Annex A4: Note to Readers

In April 2015, Treasury Metals Inc. (Treasury Metals) submitted an Environmental Impact Statement (EIS) for the proposed Goliath Gold Project (the Project) to the Canadian Environmental Assessment Agency (the Agency) for consideration under the Canadian Environmental Assessment Act (CEAA), 2012. The Agency reviewed the submission and informed Treasury Metals that the requirements of the EIS Guidelines for the Project were met and that the Agency would begin its technical review of the submission. In June 2015, the Agency issued a series of information requests to Treasury Metals regarding the EIS and supporting appendices (referred to herein as the Round 1 information requests). The Round 1 information requests included questions from the Agency, other federal and provincial reviewers, First Nations and other Aboriginal peoples, as well as interested stakeholders. As part of the Round 1 information request process, at the request of the Agency, Treasury Metals has consolidated the responses to the information requests into a revised EIS for the Project.

The enclosed document provides the final responses to the 90 Round 1 information requests included as

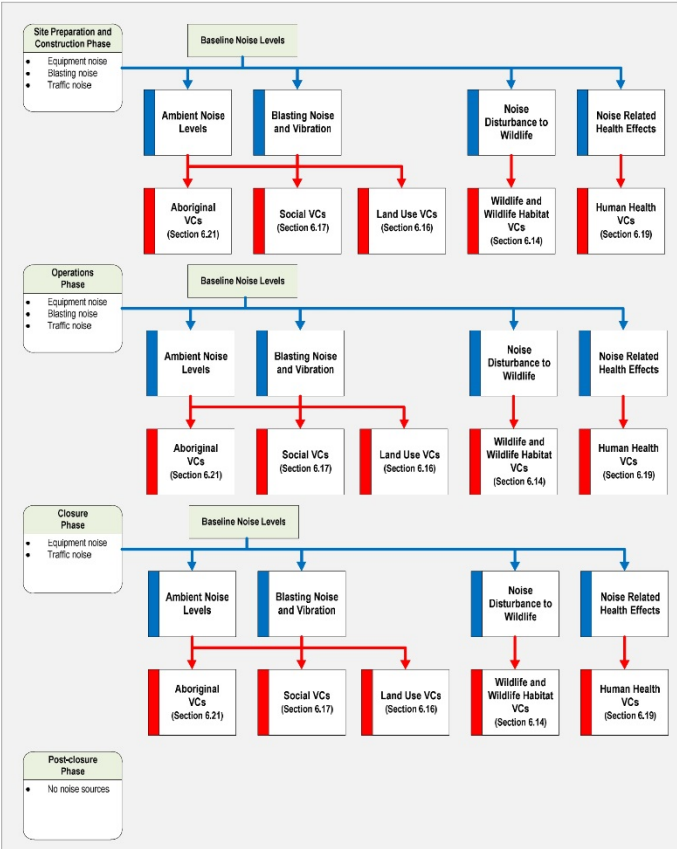
757	PC(1)-72	Member of the public			<p><u>Information Request / Comment:</u> If the waste rock pile is potentially acid generating like the proponent claims it likely will be to some degree, why can it not be planned to be further from the lake? The current design shows the waste rock pile being very close to the lake. It could be moved much farther away for safety.</p>

TMI #	Agency Reference #	Parties Asking Questions	Reference to EIS	Reference to EIS Guideline	Comment / Information Request / Response
					<p>Response: The siting of the waste rock storage area (WRSA) was considered in the Alternatives Assessment summarized in Section 2 of the revised EIS and presented in Appendix X. The WRSA is located adjacent to the open pit, which reduces the haul distances and associated air and noise emissions. It is also located generally up slope from the open pit so that the runoff from the WRSA can be directed to the open pit where it will be collected and conveyed to the on-site water management system.</p> <p>Since the submission of the original EIS, Treasury Metals has been advancing their engineering for the Project. A summary of the refinements to the Project since the completion of the original EIS is presented in Section 3.16 of the revised EIS. One of the refinements presented in the Project Update Report is a change to the slope of the WRSA. As a result of these changes, the entire footprint of the WRSA is now located within the Blackwater Creek catchment area. None of the WRSA footprint is within the catchment area for Thunder Lake.</p>
